Groundwater Application Review Summary Form

Application # G- 19379

GW Reviewer Dennis Orłowski Date Review Completed: November 9, 2023

PUBLIC INTEREST REVIEW FOR GROUNDWATER APPLICATIONS

Well Location Map

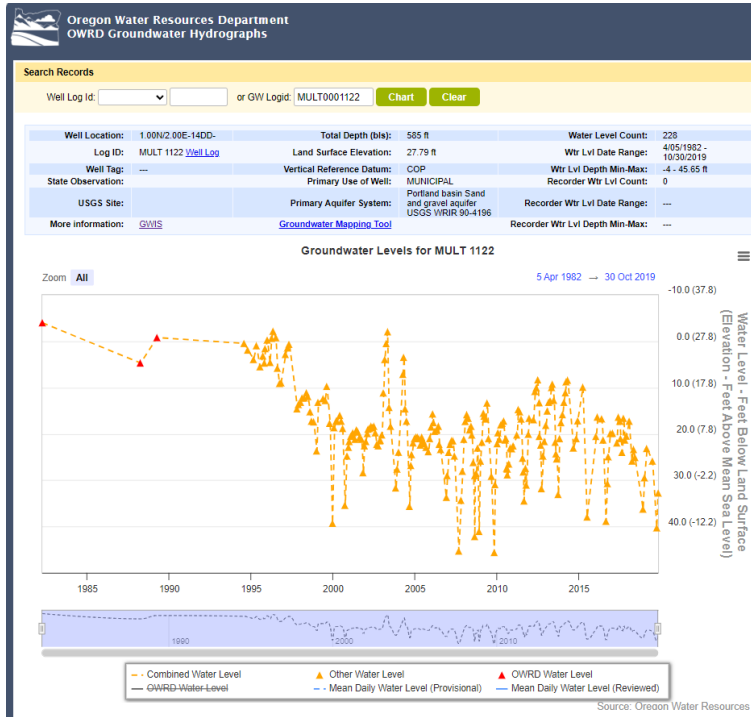
A4. **Comments:** This application is for using groundwater pumped from a single well for commercial uses, with a proposed maximum instantaneous pumping rate of 1.0 cfs (~450 gpm) and annual volume of 302 acre-feet. The POA/POU location is in a heavily commercialized portion of Multnomah County, about 250 feet from the Columbia River and just over one mile east of I-205. The application states that the targeted aquifer is the Sand and Gravel Aquifer (SGA), one of several discrete aquifer systems in the Portland Basin (Swanson and others, 1993).

- B3. **Groundwater availability remarks:** The proposed POA location is within the Portland Basin, an area of thick accumulations of alluvial sediments marked by the presence of several major aquifer systems (listed from shallowest to deepest): Unconsolidated Sedimentary Aquifer (USA), Troutdale Gravel Aquifer (TGA), Troutdale Sandstone Aquifer (TSA), and the Sand and Gravel Aquifer (SGA). In this area the three deeper aquifers are separated by significant confining units: Confining Unit 1 (CU1) and Confining Unit 2 (CU2) (Swanson and others, 1993; Morgan and McFarland, 1996; Woodward and others, 1998). The SGA, the deepest of the Portland Basin aquifers, is very prolific and serves as a groundwater source for several municipalities. This proposed POA is also targeting the SGA as its source. Historic groundwater levels in the SGA near the proposed POA location are very stable, only recently showing a modest declining trend during the past few years of drought conditions (see attached hydrograph).

Groundwater development in the area is relatively low, with the exception of periodic municipal pumping by the Portland Water Bureau. The location is within the Bureau's Columbia South Shore Wellfield, and one municipal well (MULT 1122) is located approximately 2000 feet east of the proposed POA. Most of the PWB wells within the wellfield obtain groundwater from the SGA; however, these groundwater sources serve as a backup to the PWB's primary surface water source (Bull Run Reservoir), and are thus only pumped periodically. There are also several nearby commercial and industrial groundwater users, but these either obtain groundwater from a different aquifer (e.g., the TGA for MULT 52396 (certificate 41556) and/or are non-consumptive ground-source heat pump wells (e.g., the USA for MULT 105704, permit G-17033).
